ANN ARBOR HISTORIC DISTRICT COMMISSION

Staff Report

ADDRESS: 220 S Seventh Street, Application Number HDC22-038

DISTRICT: Old West Side Historic District

REVISED FIRST FLOOR PLAN
 0 5 10

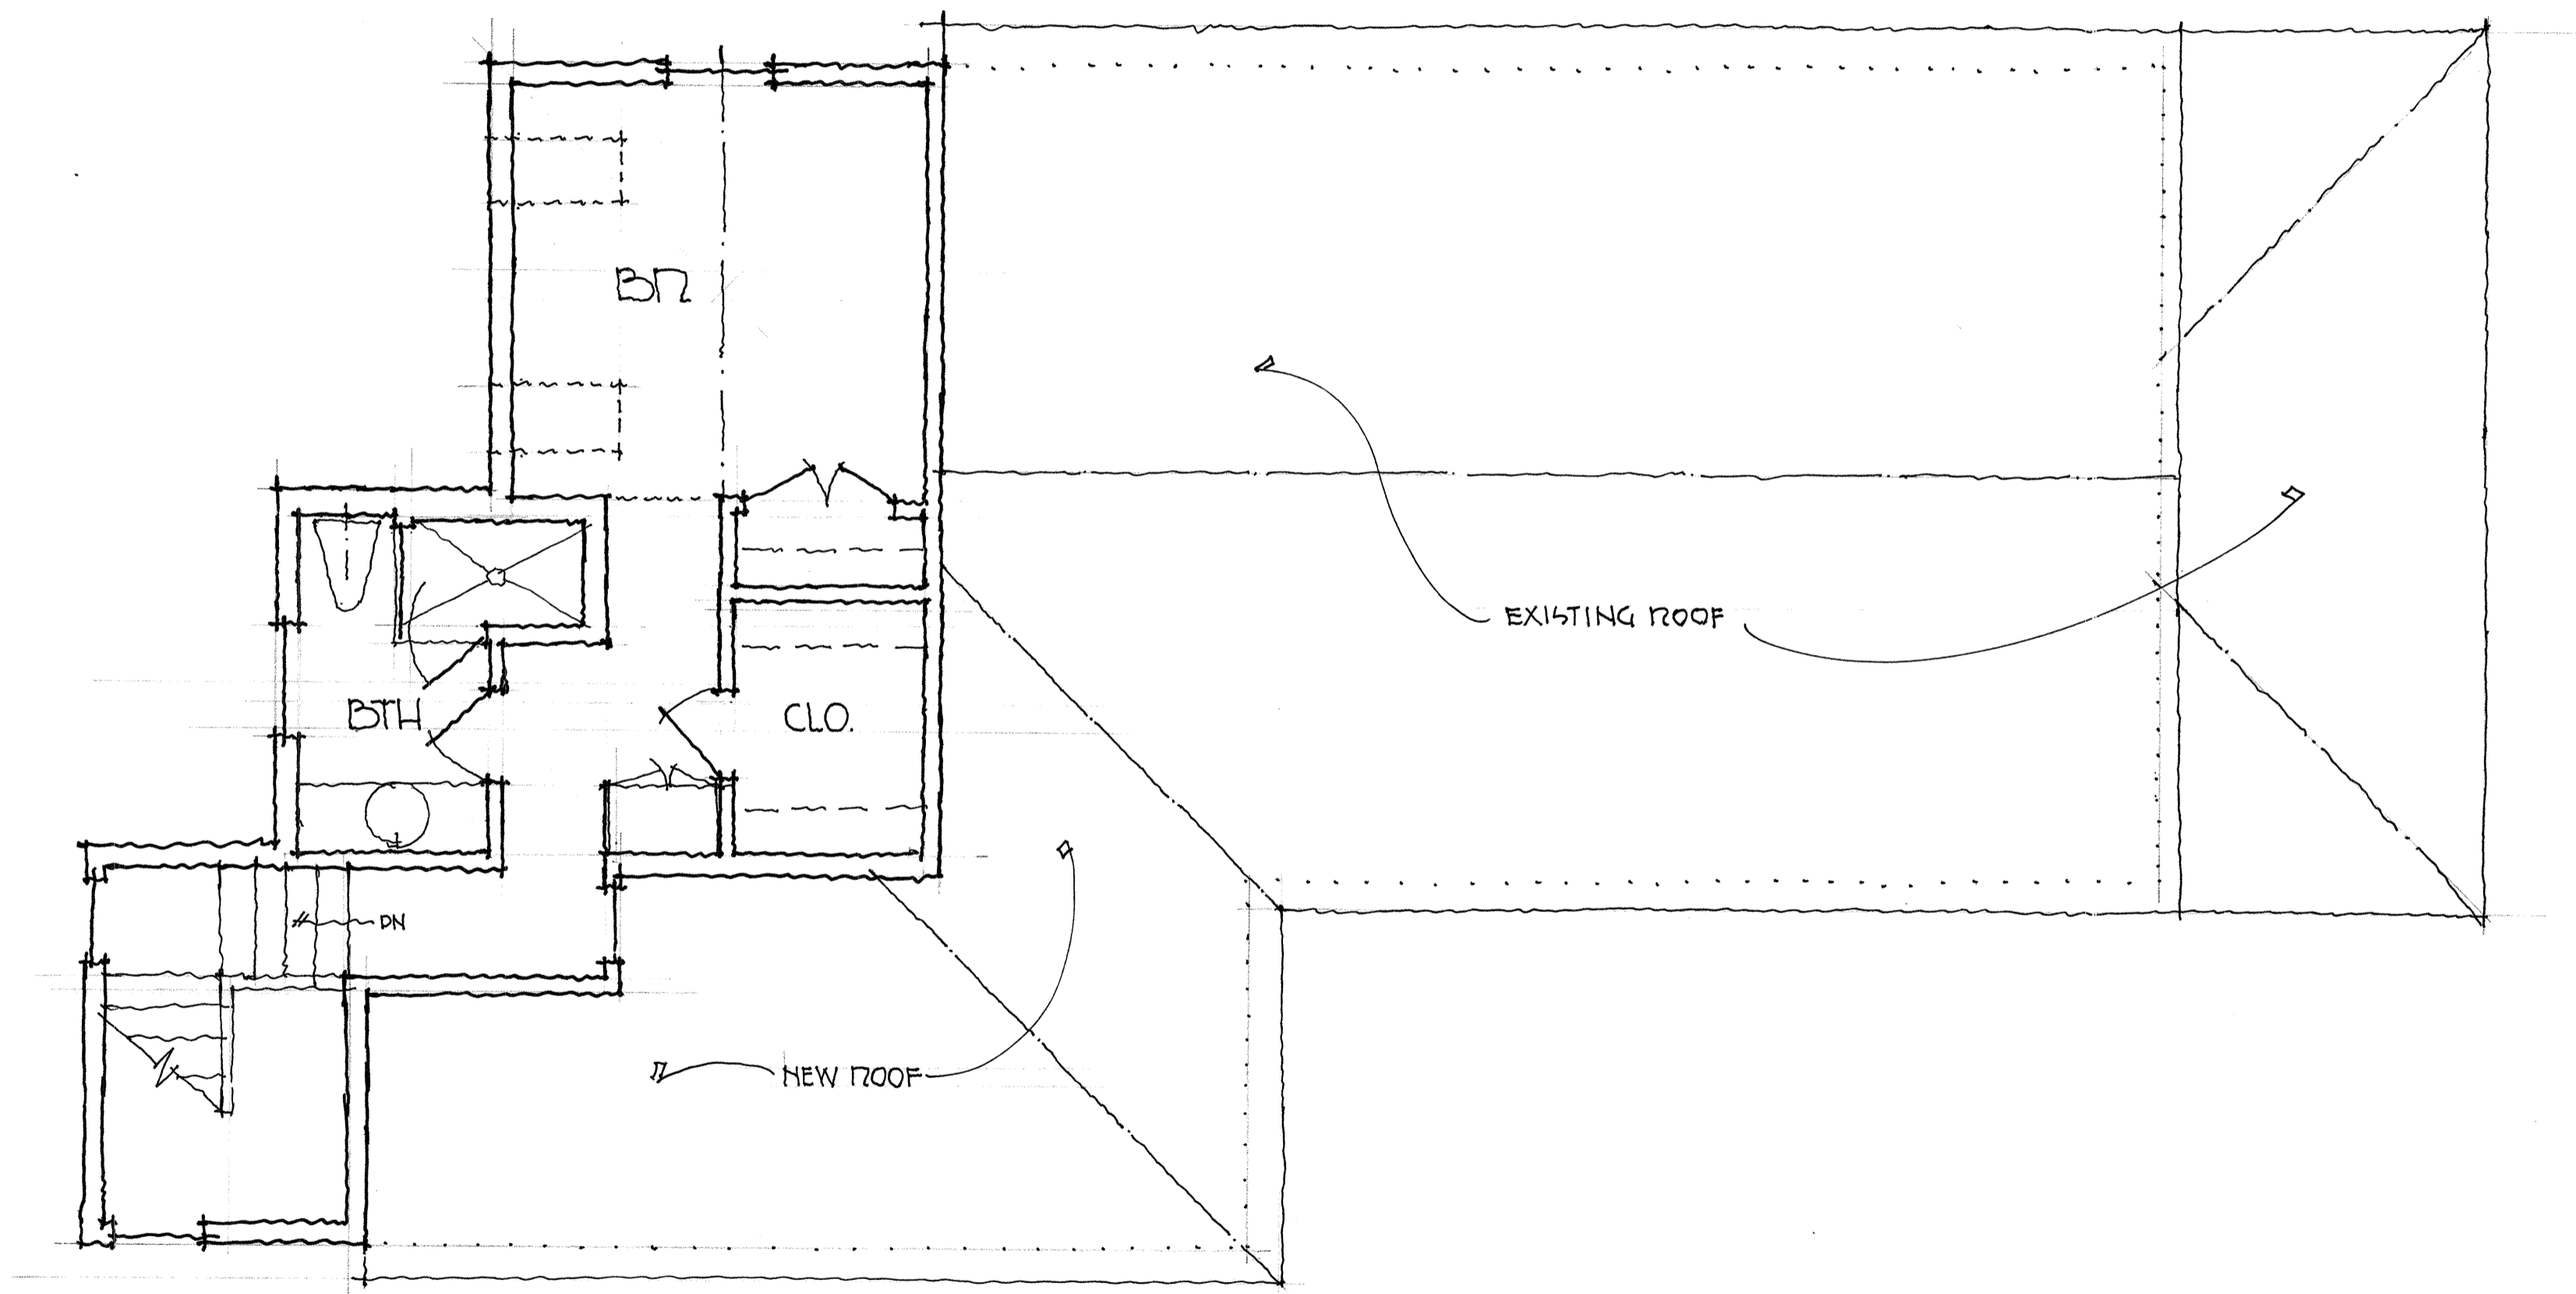
4. The addition would sit on top of the existing modern rear additions. A new stair would replace a screened porch off the rear of the house. The addition has side- and rear-facing gables in an attempt to make the addition less prominent than a street-facing gable might be. The gable heights vary; the most prominent one has a ridge 6'6" above the ridge of the existing house. The roof of the original kitchen addition on the south side of the house is reworked from a shed into a hip to tie into the addition.

NEW SECOND FLOOR PLAN
 0 5 10

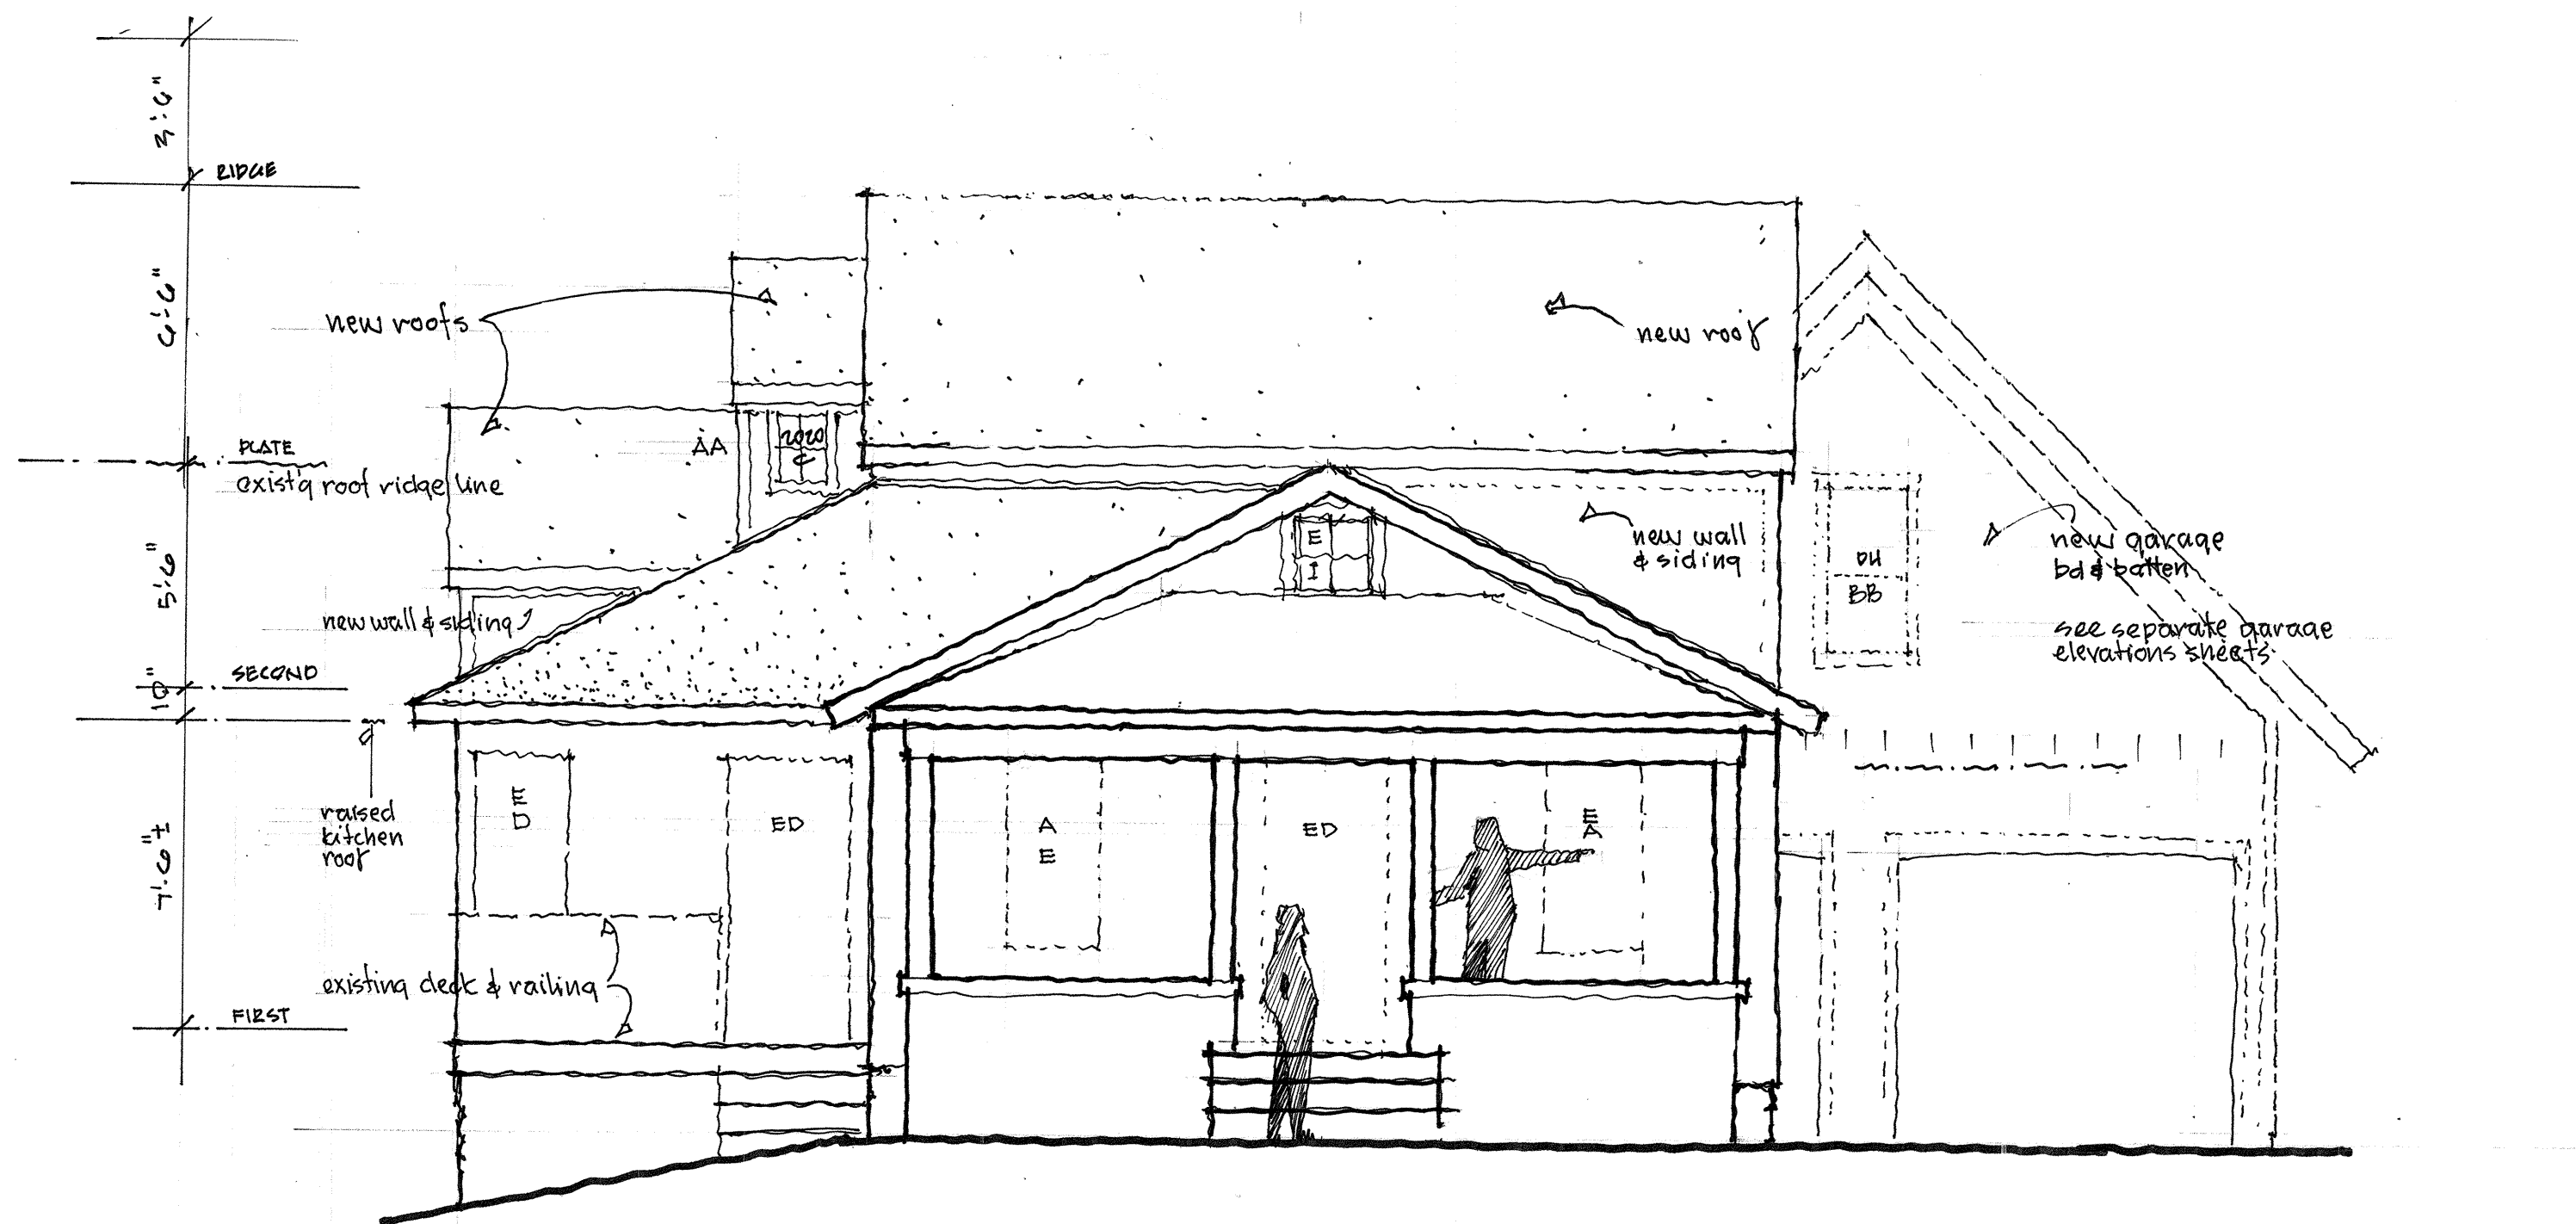
3. The house is currently 1,295 square feet (SF). The pre-1945 footprint was 932 sf, and the more modern existing additions add 363 sf, for a total footprint increase of 39%. The pre-1945 floor area was the same, 932 sf, and the additions add 363 sf (existing), and 296 sf (proposed) for a total increase of 659, or 70.7% of the pre-1945 structure. This significantly exceeds the local historic district design guideline that says the addition should not exceed 50% of the original building's total floor area.
